CITY OF NEWTON, MASSACHUSETTS

<u>Petition #233-07</u> of THOMAS MURPHY for a SPECIAL PERMIT/SITE PLAN APPROVAL and to EXTEND A NON-CONFORMING STRUCTURE to replace

two existing rear decks with two slighting larger rear decks at a two-family dwelling at 15-17 WELDON ROAD, Ward 1, NEWTON on land known as Sec 12, Blk 22, Lot 14, containing approximately 11,113 sf of land in a district zoned

EXECUTIVE SUMMARY

Figure 2. Narrow entrance drive and deck location.

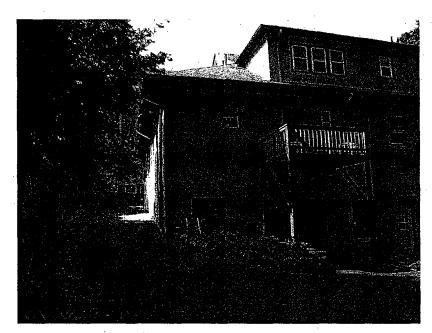
The site design calls for external stairs leading from the two proposed decks into the driveway area. In the case of the stairs closest to the entrance drive, according to the petitioner's plans, a small portion of the stairs is shown in the paved driveway area. The CZCO identified this issue in his report and a site visit by Planning Department staff confirmed that the driveway area is very limited and it is not clear that there will be adequate maneuvering space for a vehicle. In addition, any person stepping off the proposed stairs into the driveway area may not be clearly visible to a driver entering the parking area at the rear of the structure. The Planning Department would strongly recommend that the stairs be redesigned such that there is no impact on the driveway area, or on the lower level entryways to the structure.

The petitioner is expected to present information at the public hearing as to how the stairs will be installed without further reducing the driveway width of the subject property.

The Planning Department would strongly recommend that the stairs be redesigned such that there is no impact on the driveway area, or on the lower level entryways to the structure.
